REMARKS

Applicant acknowledges the receipt of the Office Action dated 12 July 2005 in which the Examiner:

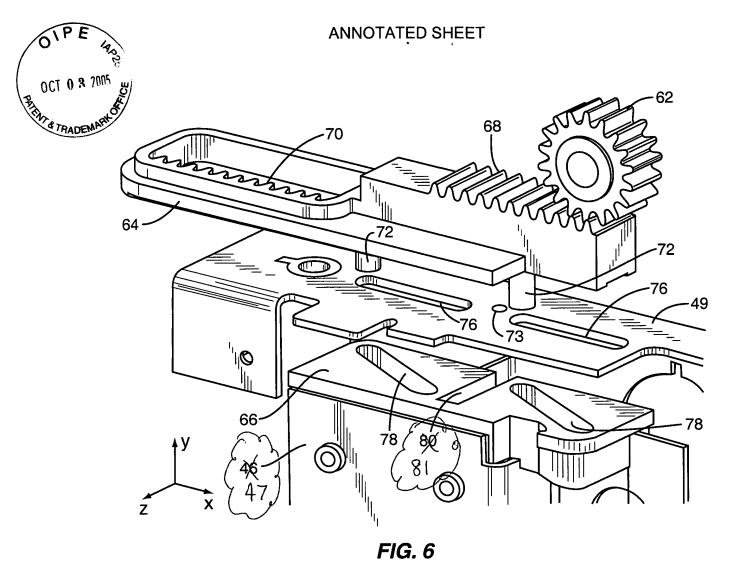
Second, the Examiner objected to the drawings as using multiple reference numbers to refer to a "retraction plate." Specifically, the reference numbers 46 and 47 are used to describe the specified retraction plate. Pursuant to this objection, Applicants have amended Fig. 6 and Fig. 7 as shown in the attached Replacement Sheet and Annotated Sheet. To maintain consistency with the specification and the remaining Figures, reference number 46 has been changed to 47 in both Fig. 6 and Fig. 7. As amended, the translating retraction plate 47 is shown in the embodiment illustrated in Figs. 5, 6, and 7 while the pivoting retraction plate 46 is shown in the embodiment illustrated in Figs. 3, 4A and 4B. Thus, reference numbers 46 and 47 now refer to different entities. These amendments correct the Examiner's grounds for objection and withdrawal of the objection is respectfully requested.

Aside from the Examiner's objections, Applicants have also amended Fig. 6 as shown in the attached Replacement Sheet and Annotated Sheet to change reference number 80 to reference number 81. The number 80 is used elsewhere in the Figures and the specification in association with a pinion gear. Thus, the Z-slot formerly referenced by the same number 80 is

now reference by the number 81. A corresponding change to the specification is presented herein. Consideration and acceptance of this amendment is respectfully requested.
